## Independent Technical Review Report: Oak Ridge Reservation

# Review of the Environmental Management Waste Management Facility (EMWMF) at Oak Ridge

1 February 2008 (v3.0)

Fig. 1. Plan view of EMWMF showing existing Cells 1-4 and area planned for Cell 5.

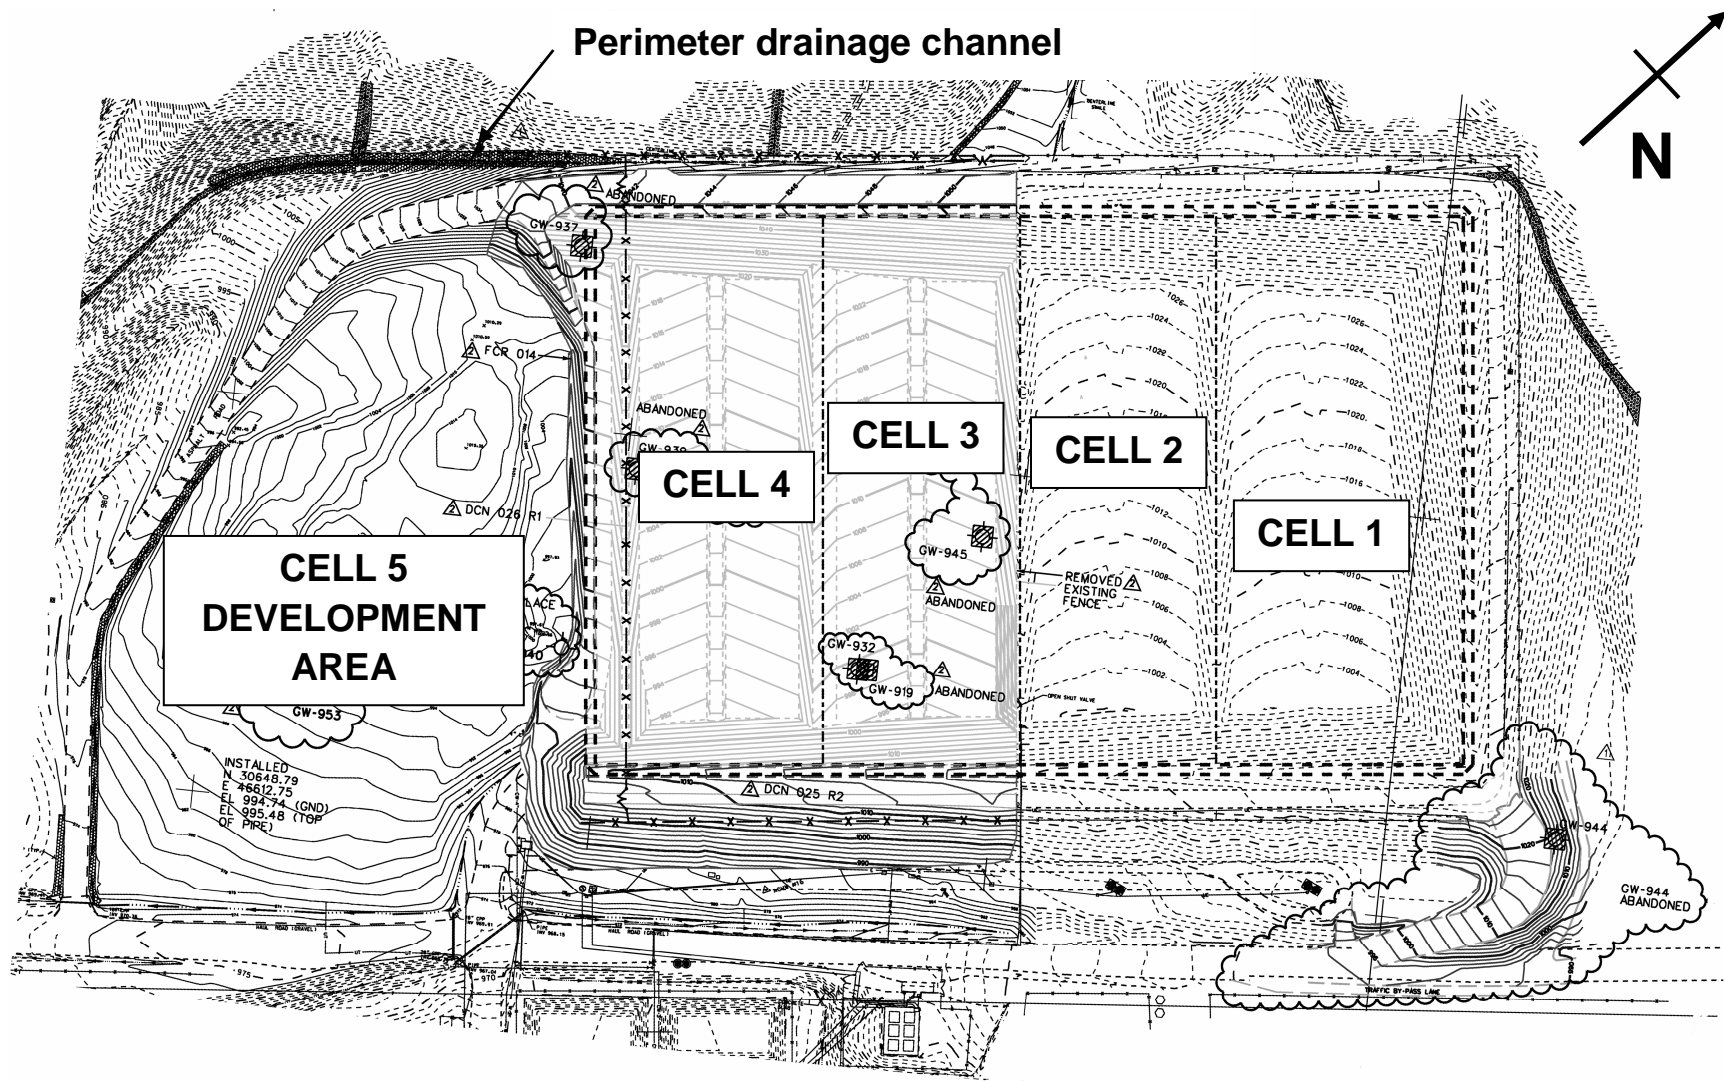
Possible expansion scenarios might include relocation of the existing diversion channel for North Tributary-4 with an associated expansion into the existing hillside north of the disposal cells, or expansion to the west and south to create a dog-leg below Cell 5 (Fig. 1). Capacity of the existing landfill footprint might also be increased by pre-loading the waste (to induce compression), by replacing some of the thicker elements in the cover with thinner geosynthetic elements (e.g., replacing the granular drainage layer with a geocomposite drainage layer, replacing a portion of the compacted clay barrier with a geosynthetic clay liner, using a geotextile in lieu of the granular filter layer), or by reducing the thickness of the surface layer. Feasibility of any of these options would require careful engineering analysis in the context of the 1000-yr design life required for the EMWMF as well as regulatory concurrence.

- Conservatively estimate the remaining landfill volume that will be needed to complete the remedial activities at Oak Ridge, and develop expansion plans for the landfill if necessary. Planning for this activity is being conducted and should continue in a timely manner. Several possible expansion scenarios should be explored. Capacity of the existing landfill footprint might also be increased by pre-loading the waste, by replacing some of the thicker elements in the cover with thinner geosynthetic elements, or by reducing the thickness of the surface layer.
- Volume requirements for future EM on-site disposal facilities should be estimated using information from past and operating disposal facilities as a guide. Waste volumes should be

Fig. 5. Schematic of cover profile planned for the EMWMF. Upper 305 mm of clay barrier near base of cover profile is amended with bentonite to reduce the hydraulic conductivity.

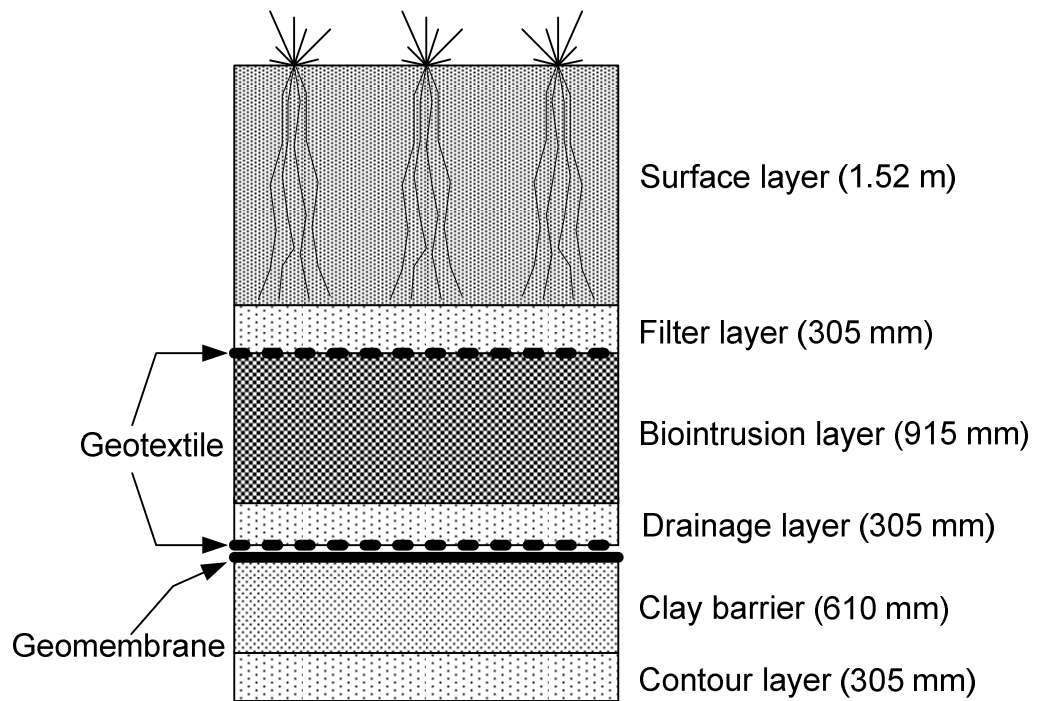
The final cover proposed for the EMWMF is a state-of-the-art multi-layer system (Fig. 5) that relies primarily on a composite resistive barrier layer (geomembrane over a clay layer) to achieve the target percolation criterion (10 mm/yr). Although flexible materials have been proposed for the barrier material (e.g., LLDPE geomembrane), the composite barrier can be affected by differential settlement. This is particularly important in a humid climate such as Oak Ridge, where resistive barrier layers play a critical role in controlling percolation into the waste. Consequently, the impacts of differential settlement should be further evaluated and the methods of waste placement should be reviewed to ensure that adequate support for the final cover will exist over the long term.

First, the waste includes soil-debris mixtures as well as grouted materials. Consequently, the stiffness of the waste will vary spatially throughout the landfill, which will contribute to differential settlement (Benson et al. 2007b). Second, the density requirement (85% relative compaction based on standard Proctor) is relatively low for an earthwork operation. Thus, the waste will be more compressible than a typical structural fill, which could result in greater settlement. Experience has also shown that a relatively low compaction requirement generally results in greater spatial variability in compaction of the fill, which will exacerbate differential settlement. Third, much of the soil mixed with the debris is fine-grained and moist or wet. Consequently, greater compression of the soil fraction will occur at the EMWMF relative to other sites where the soil fraction is coarse-grained (e.g., as at ERDF or ICDF). Compression of the soil matrix will also be time dependent due to the dissipation of excess pore pressures in the fine-grained soil over the relatively long drainage distance imposed by the cell geometry ( $\approx 11$  m assuming double drainage). Secondary compression of the fine-grained soil fraction may also be appreciable and spatially variable.

While recognizing the significant effort made to date to ensure appropriate waste placement and compaction, the ITR team recommends that the compaction criterion, void space criterion for grouting, and settlement of the waste in the EMWMF continue to be re-evaluated. This re-evaluation should consider the impacts of differential settlement caused by variations in stiffness,

time-dependent primary compression of the fine-grained soil matrix, and long-term creep settlement of the soil matrix and the debris. To the extent practical, a quantitative linkage should also be developed between the predicted settlement of the cover and the criteria for waste compaction and maximum void space. An increase in the required minimum density of the waste should also be considered along with a test fill or preloading test to quantify the settlement of the waste under expected loads applied by the final cover. A preloading test could also be used to quantify gains in landfill volume accrued by compressing the waste mass. Consideration should also be given to the timing of completion of waste placement prior to construction of the final cover. The period between completion of waste placement and cover construction could be used to assess overall and differential settlement.

- The compaction criterion, void space criterion for grouting, and settlement of the waste in the EMWMF should be re-evaluated to assess the potential for differential settlement caused by variations in stiffness, time-dependent primary compression of the fine-grained soil matrix, and long-term creep settlement of the soil matrix and the debris. To the extent practical, a quantitative linkage should be developed between the predicted settlement and the criteria for waste compaction.
